1.0 DEFINITIONS

CONFINEMENT BOUNDARY - The surface surrounding the reactor facility defined by the interior partition walls of offices and laboratories on the north, east and south sides of the building and by the west interior wall which isolates the basement, first floor, and the west corridor of the second floor from the central bay.

CONFINEMENT SECURED - The confinement shall be considered secured when:

REVISED OCT 1996

BASEMENT FLOOR PLAN

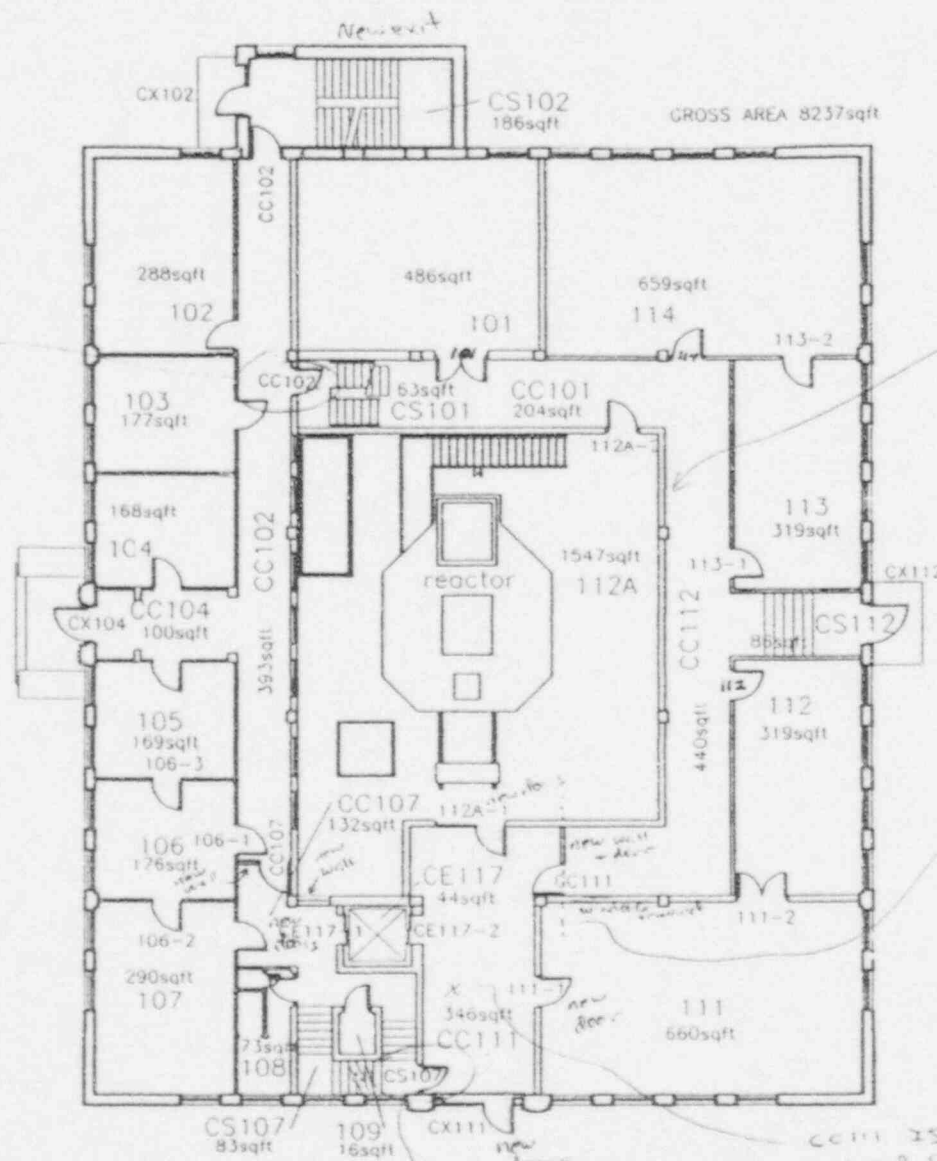
reactor room wall
does not extend to ceiling
ie. CC 101 & CC 112 are NOT
isolated from 112A

Elevation view
of CC III (hallway)

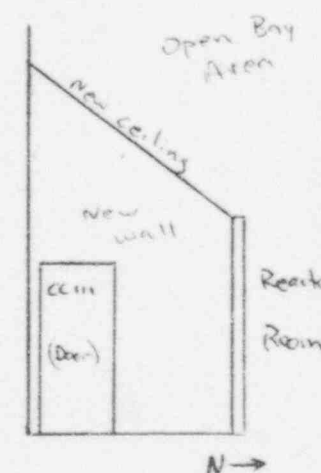
CC11 25
isolated from
112A by dec. 11241
b.t. still inside
the confinement
boundary

FIRST FLOOR PLAN

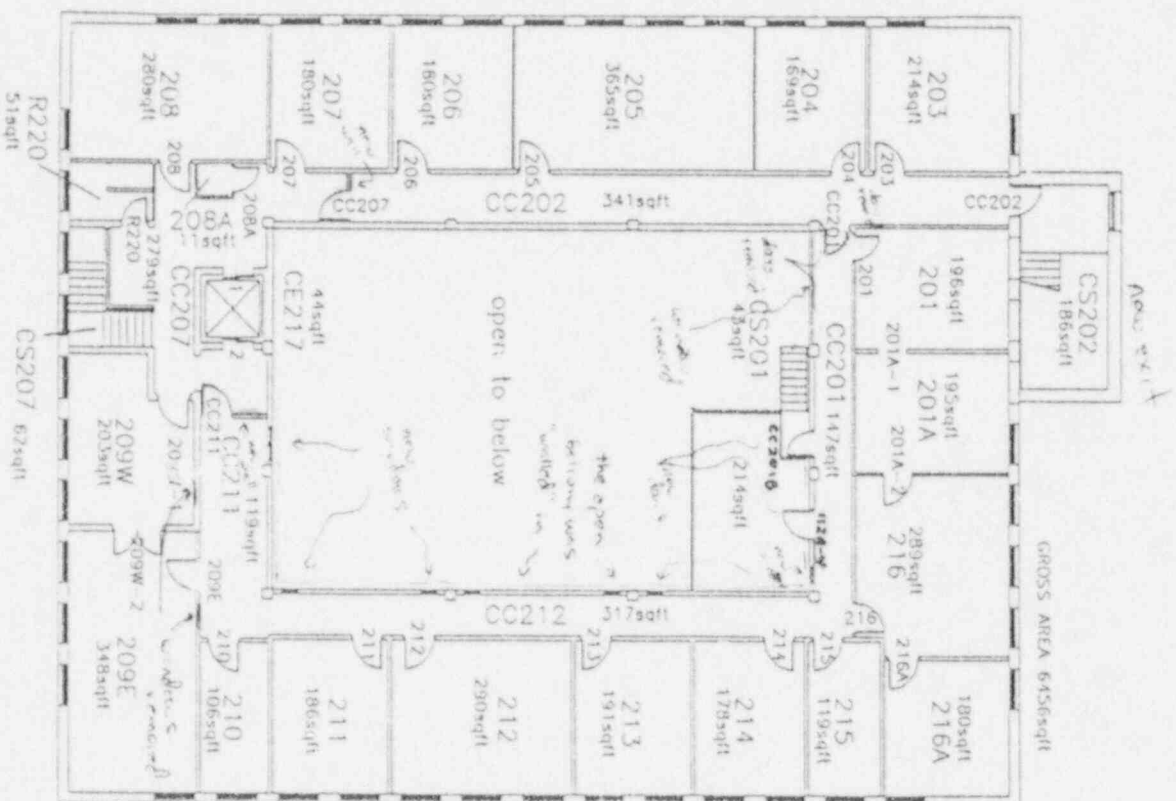
the two doors 112A-4 and
CC201B are two only and
floor penetrations/openings
into the machine bay
